Planning Commission Staff Report

Item 3

Applicant: Maverik

Consideration of an amendment to the Whiting Commercial subdivision plat creating two new commercial lots, and consideration of Project Plan and Conditional Use Permit applications for a Maverik gas station located at 1600 South and Highway 89.

LANDSCAPE PLAN

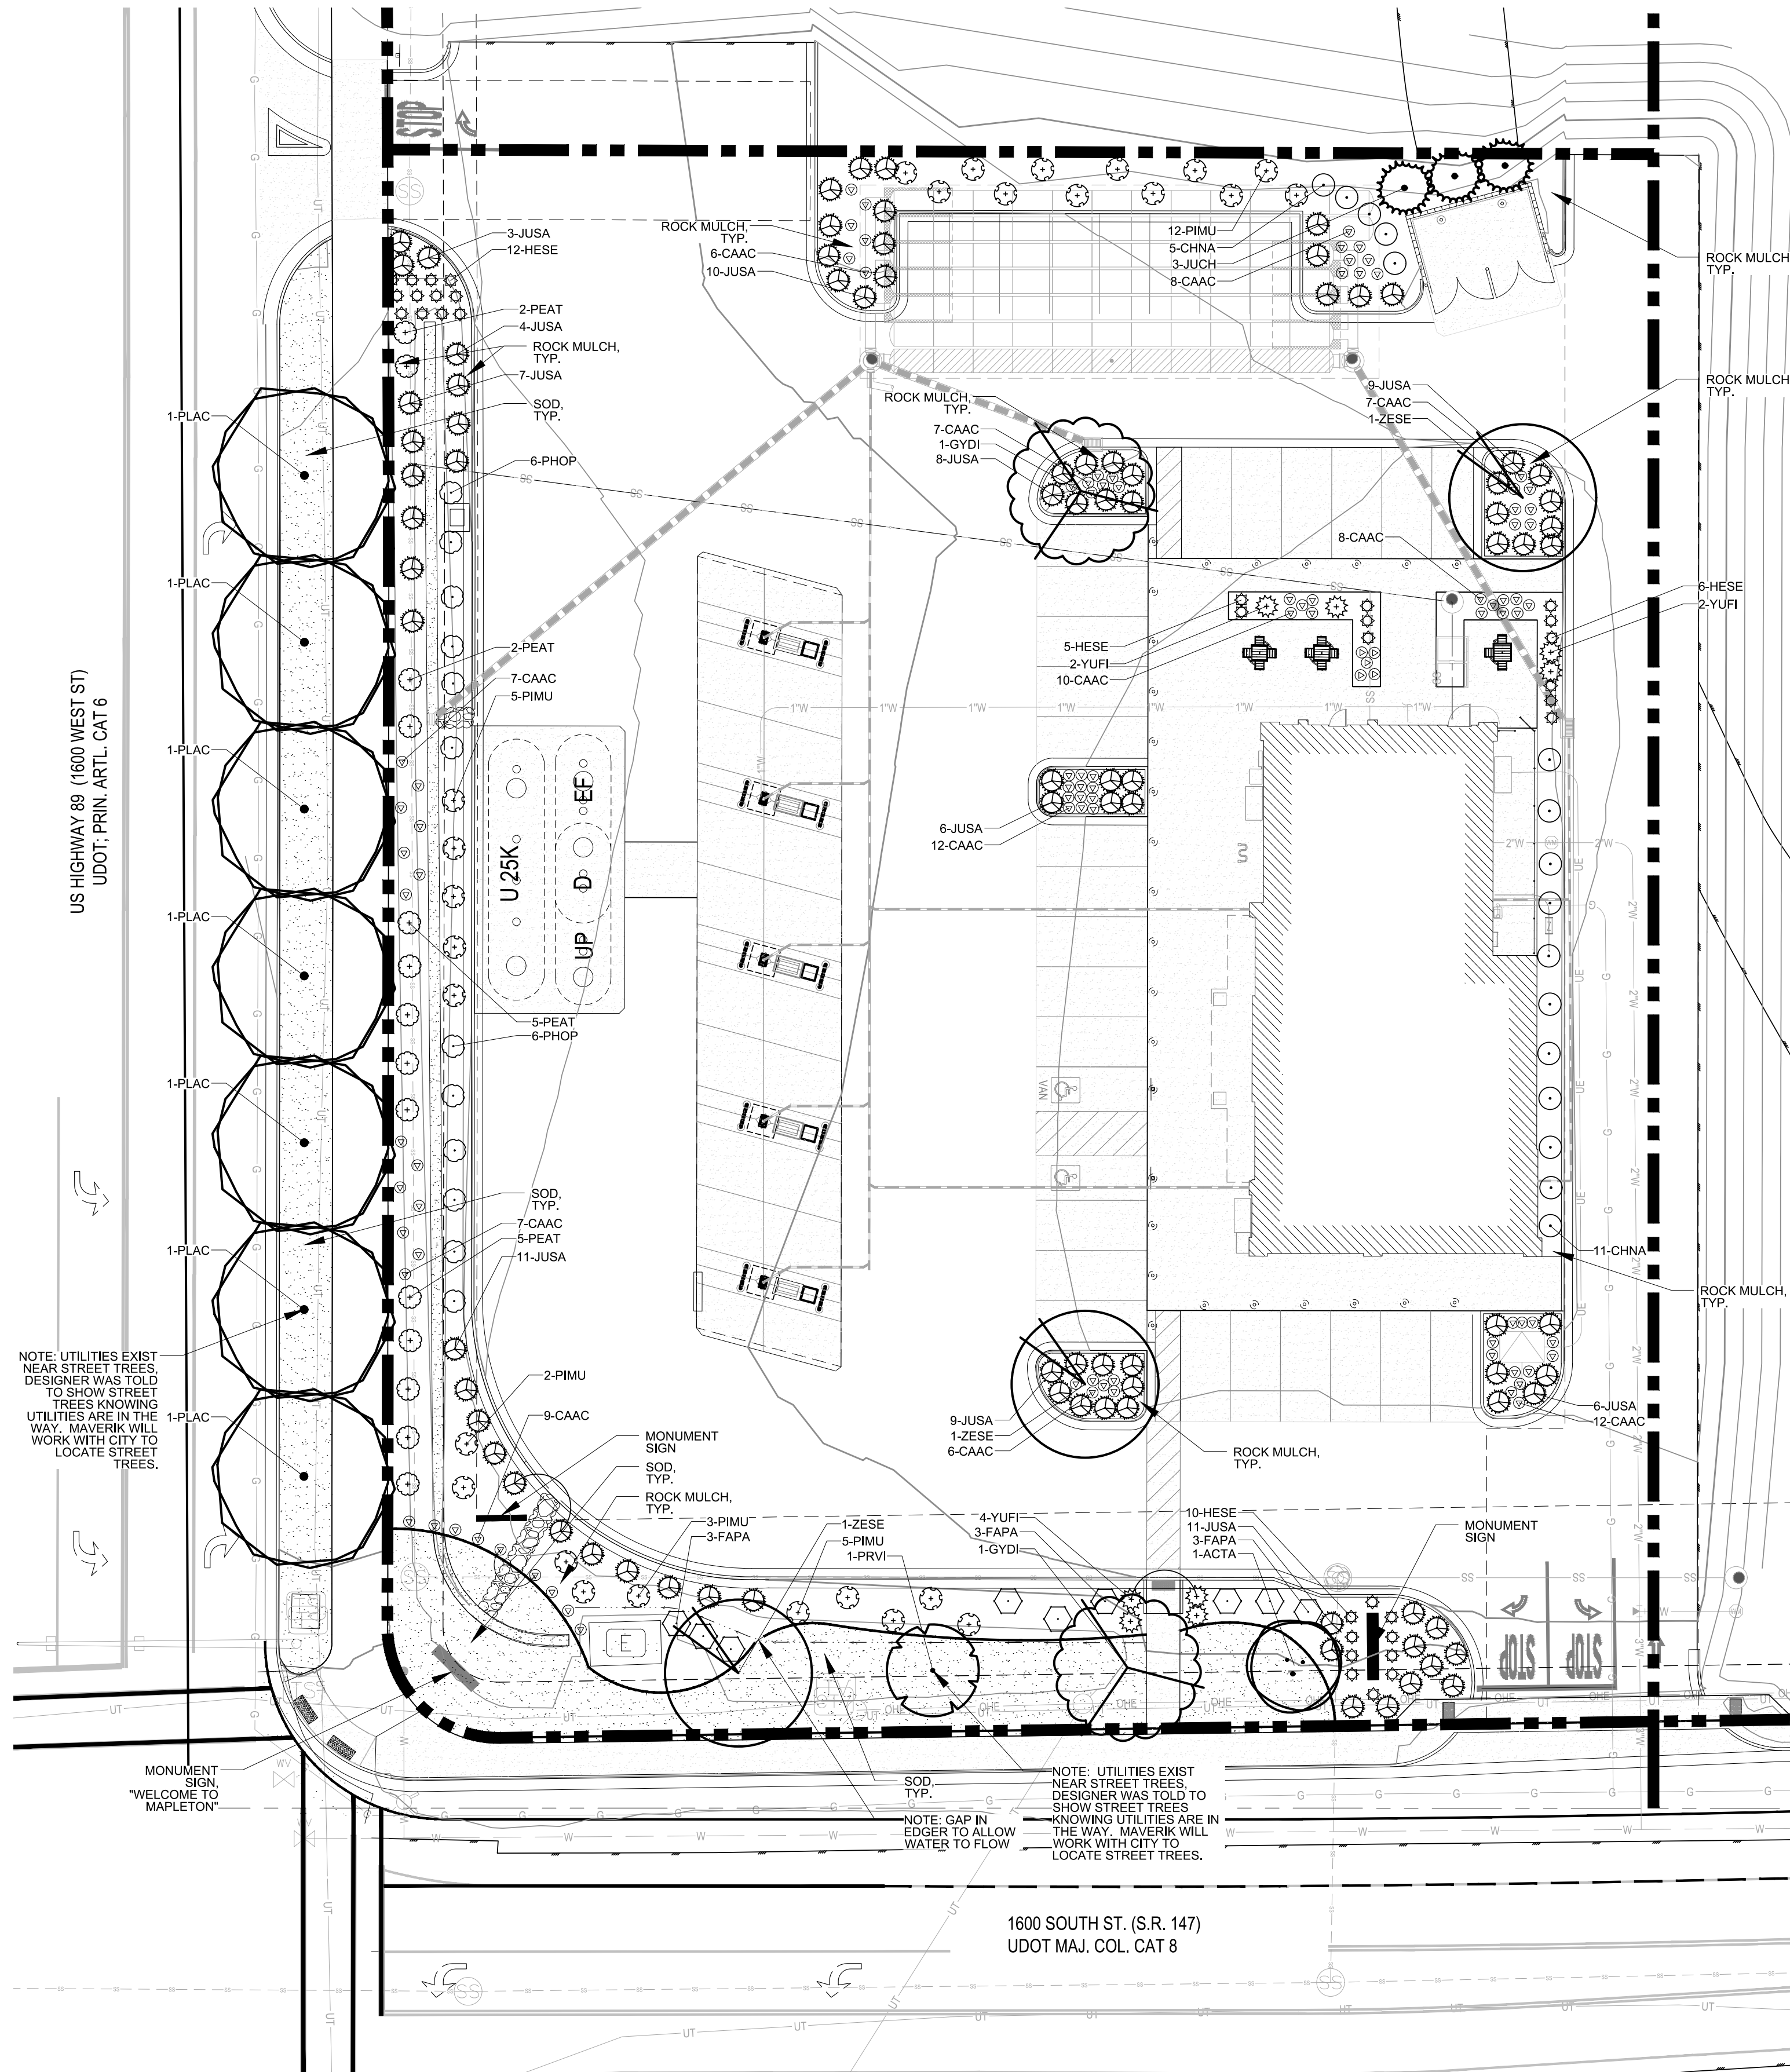
18.90.060 – Landscaping: This chapter requires a minimum of 20% of the site be landscaped and that no more than 60% of landscape area to be turf grass. Street trees are required in the planter strip along the road and in the landscape islands. The proposal is generally consistent with this chapter.

**NOTE: UTILITIES EXIST NEAR STREET TREES,
DESIGNER WAS TOLD TO SHOW STREET TREES
KNOWING UTILITIES ARE IN THE WAY. MAVERIK WILL
WORK WITH CITY TO LOCATE STREET TREES.**

1. The applicant shall submit final subdivision plans including utility plans for Final Plat approval to the Development Review Committee.
2. The building permit plans shall include a lighting plan for the gas canopy. All canopy lights shall be flush with the lower surface of the canopy or recessed to limit light pollution off the site.
3. No more than 60% of on-site landscaping shall be in turf grass. The final landscape plan shall include a note identifying the total area proposed for turf grass.
4. One tree is required in each parking lot planter.

1 FUEL DISPENSING CANOPY STREET ELEVATION
SCALE: 1/4" = 1'-0"

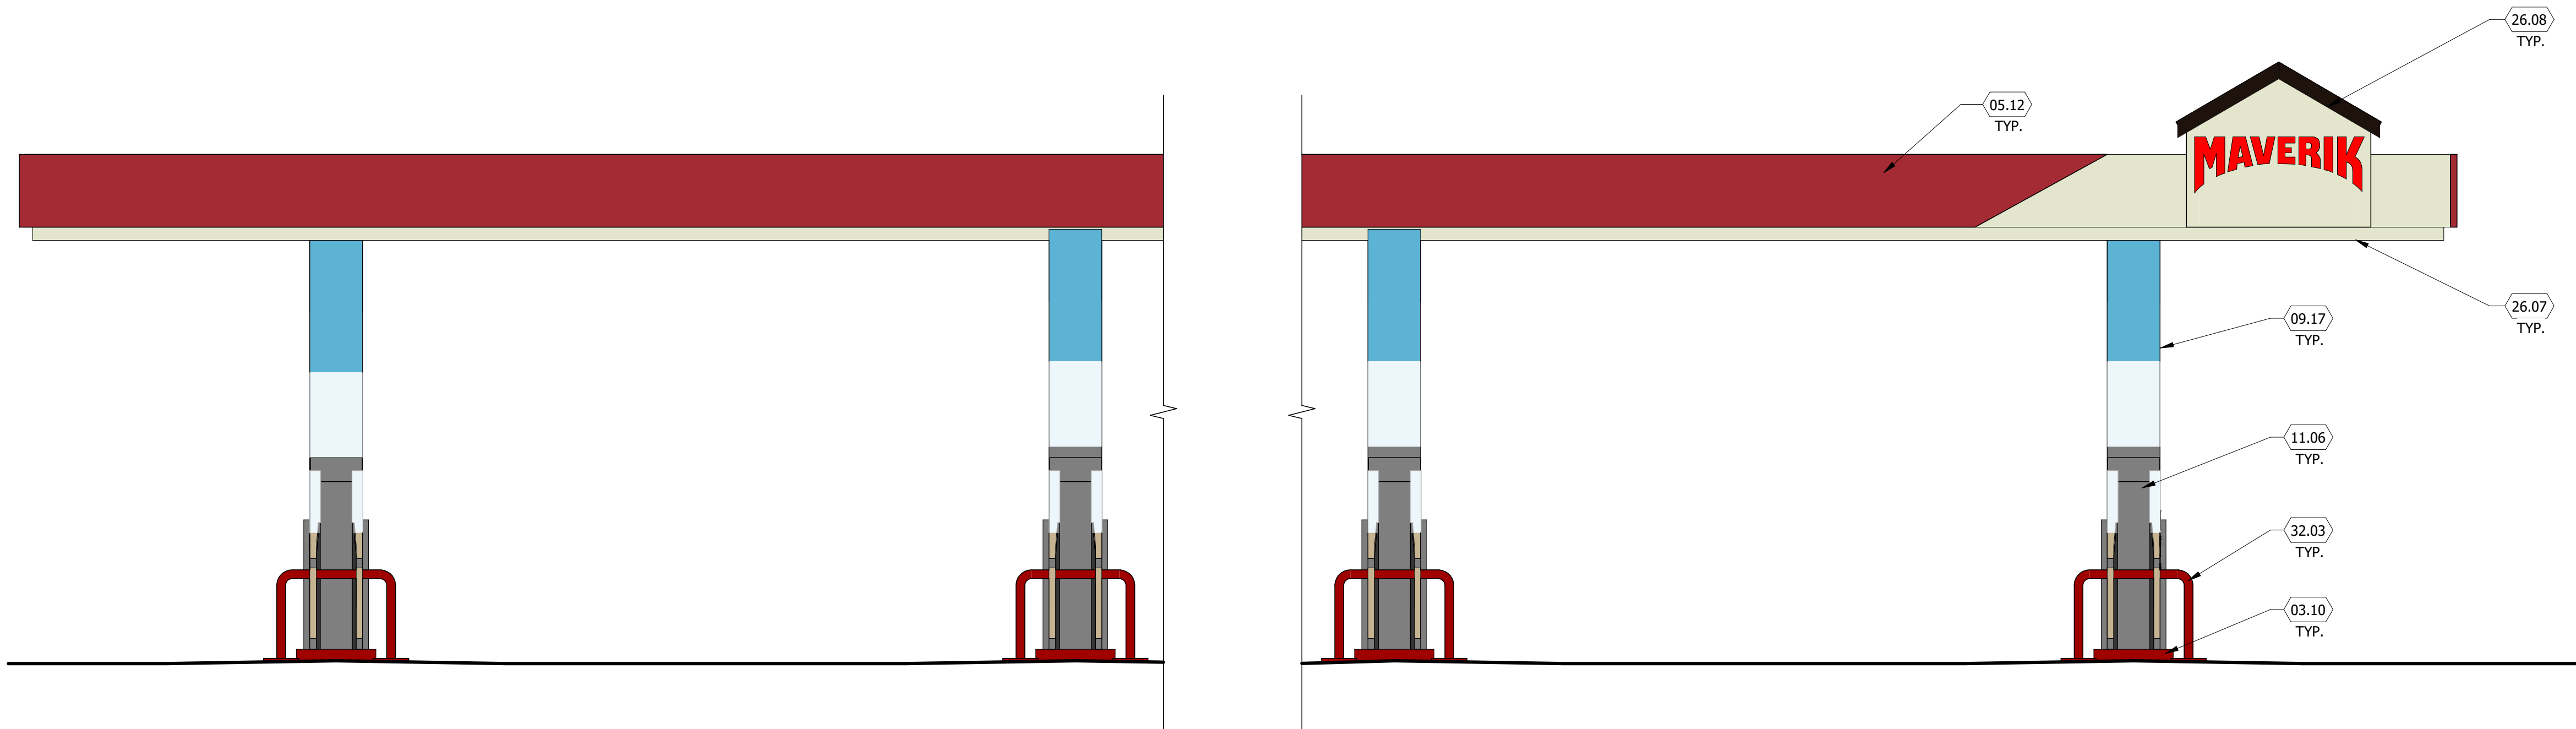
18.90.050 – Lighting: This chapter requires a street light for every 100 feet of frontage on a city street. The applicant will pay a fee to the City and the City will have the lights installed by Rocky Mountain Power. This section also requires all gas station canopy lighting be flush with the lower surface of the canopy to limit light pollution off the site. The canopy lighting will be reviewed during building permit submittal.
